Our File: 0004

August 9, 2023

**Re: Mill Creek Aggregates Pit –Review of 2022 Monitoring Data
Part Lot 24, Concession 1, and
Part Lots 21, 22, 23, and 24, Concession 2**

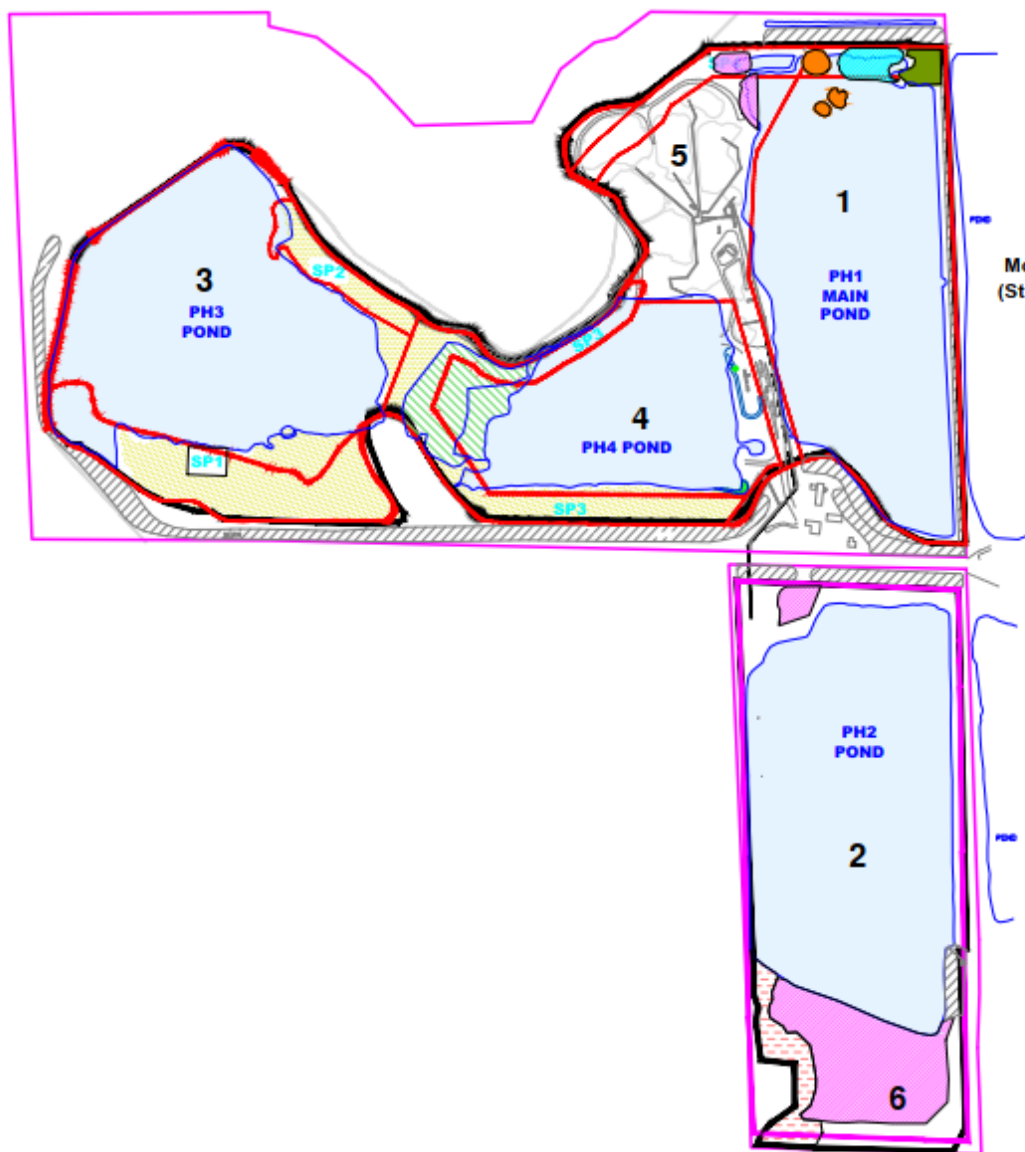
In 2022 the extractive activity that occurred was above water table and below water table extraction in Phase 2,5 and 6 (see attached figure) as well as in Silt Pond 4. Aggregate processing also occurred which involves pumping water from Phase 1 through an aggregate sorting plant and discharge of effluent into Silt Pond 4 and in Phase 1 to allow for settlement and containment of non-marketable fine-grained materials. This silt pond is located between the main Phase 1 pond and Mill Creek.
